II. Project Review Process and Timeline

The Planning Board is being asked to review the proposal pursuant to the following ordinances:

- Ch. 702, Site Plan Review; and
- Ch. 703, Character Based Development Code (CBDC) Building & Lot Plan, CD4 Village Center Character District.

West Elevation (Internal to Railroad Square)

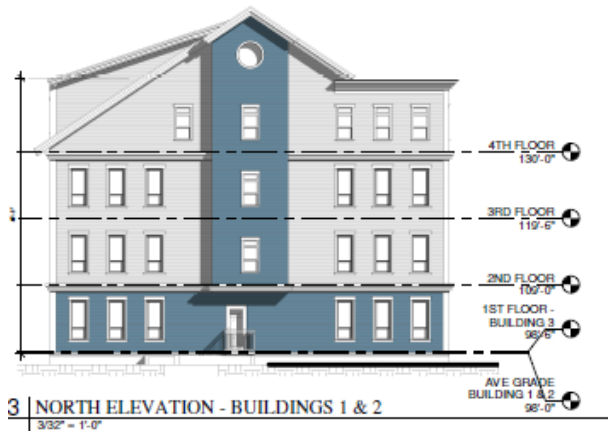
Between the two buildings, there are 42 residences. A waiver is requested for four stories (please see the discussion at the end of this section). Parking is proposed to be located underneath the building.

Lighting Standards (Article 5.P)

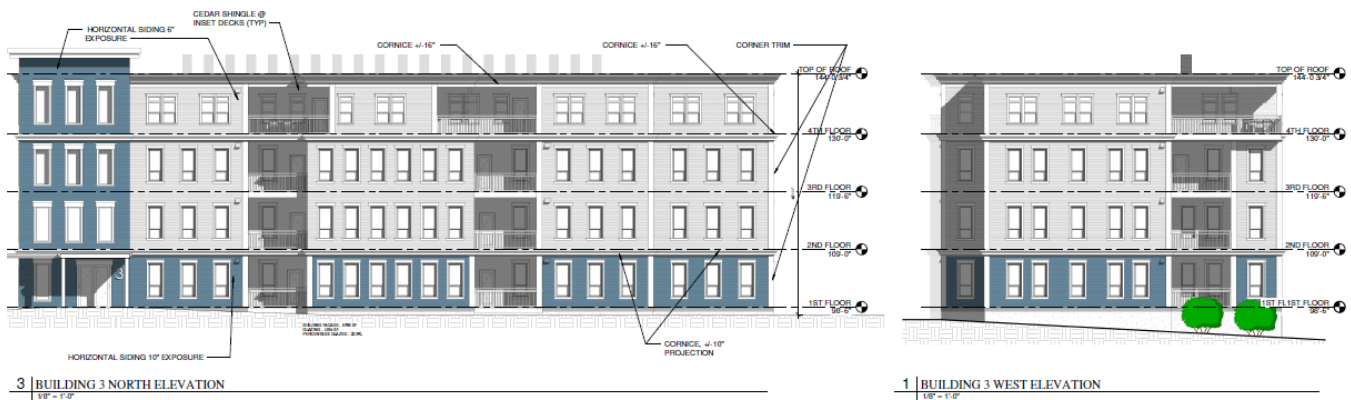
An updated photometric plan was provided, and it appears that it is in compliance with the required standards for outdoor lighting. Note that lighting inside the residences is not regulated.

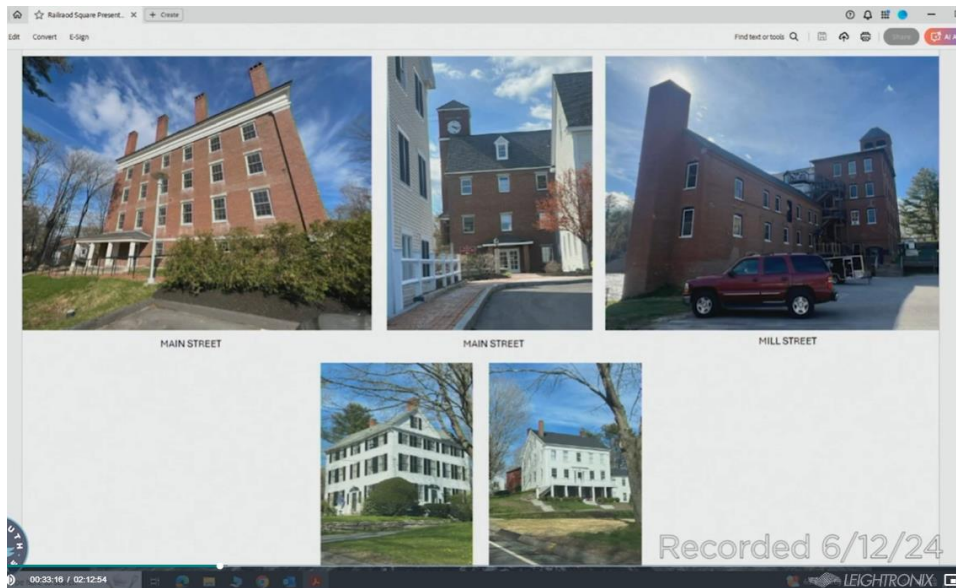
The 4th story will be a prominent feature of the Village skyline

The applicants have provided many artistic renditions of the future buildings as seen from carefully chosen angles. We would like to offer an additional perspective, as seen from the most travelled road that has visibility into the heart of Yarmouth’s Village (Route 1 over Main St.):

45' above grade at RRSQ
would be ~20ft above the
roofline of Hancock Lumber.

The RRSQ roofline will become
a dominant feature of the
skyline – and the only structure
above the treeline – as viewed
from Route 1 over Main St

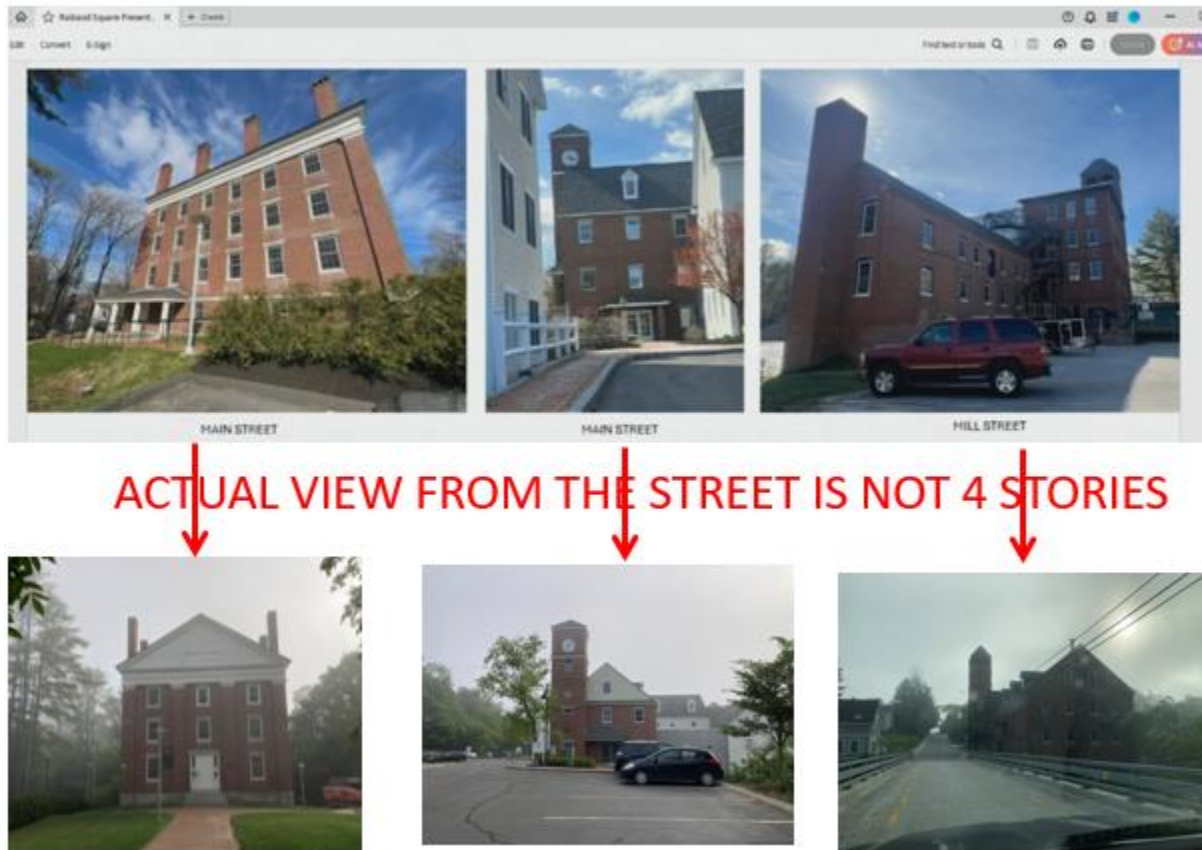
We also feel that the developer has provided deceptive “instances of historic precedence of 4 story buildings” in Yarmouth. For example, the developer showed these instances as justification as part of their presentation on 6/12/24:

All of these photographs were taken from the downslope side of buildings, and the photographs of the non-residential buildings (NYA, Intermed, Sparhawk Mill) are taken from private property, not from the street view that is seen by Yarmouth residents.
